Economic Commission for Europe**Inland Transport Committee****World Forum for Harmonization of Vehicle Regulations****Working Party on Passive Safety****Fifty-ninth session**

Regulation No. 16 (Safety-belts)**Proposal for an 07 series of amendments to Regulation No. 16
(Safety-belts)****Submitted by the expert from Australia***

The text reproduced below was prepared by the expert from Australia and aims at introducing provisions for airbag de-activation devices (where fitted). It is based on informal document GRSP-58-14 distributed at the fifty-eighth session of the Working Party on Passive Safety (GRSP). The modifications to the current text of UN Regulation No. 16, including draft Supplement 7 to the 06 series of amendments (ECE/TRANS/WP.29/GRSP/2015/25), are marked in bold for new or strikethrough for deleted characters.

"Annex 2

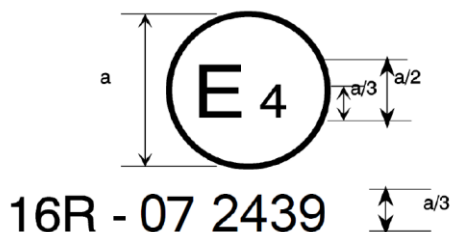
The above approval mark affixed to a vehicle shows that the vehicle type concerned has, with regard to safety-belts, been approved in the Netherlands (E 4) pursuant to Regulation No. 16. The approval number indicates that the approval was granted according to the requirements of Regulation No. 16 as amended by the **07** series of amendments.

The above approval mark affixed to a vehicle shows that the vehicle type concerned has been approved in the Netherlands (E 4) pursuant to Regulations Nos. 16 and 52.¹ The approval numbers indicate that, at the dates when the respective approvals were given, Regulation No. 16 included the **07** series of amendments and Regulation No. 52 the 01 series of amendments."
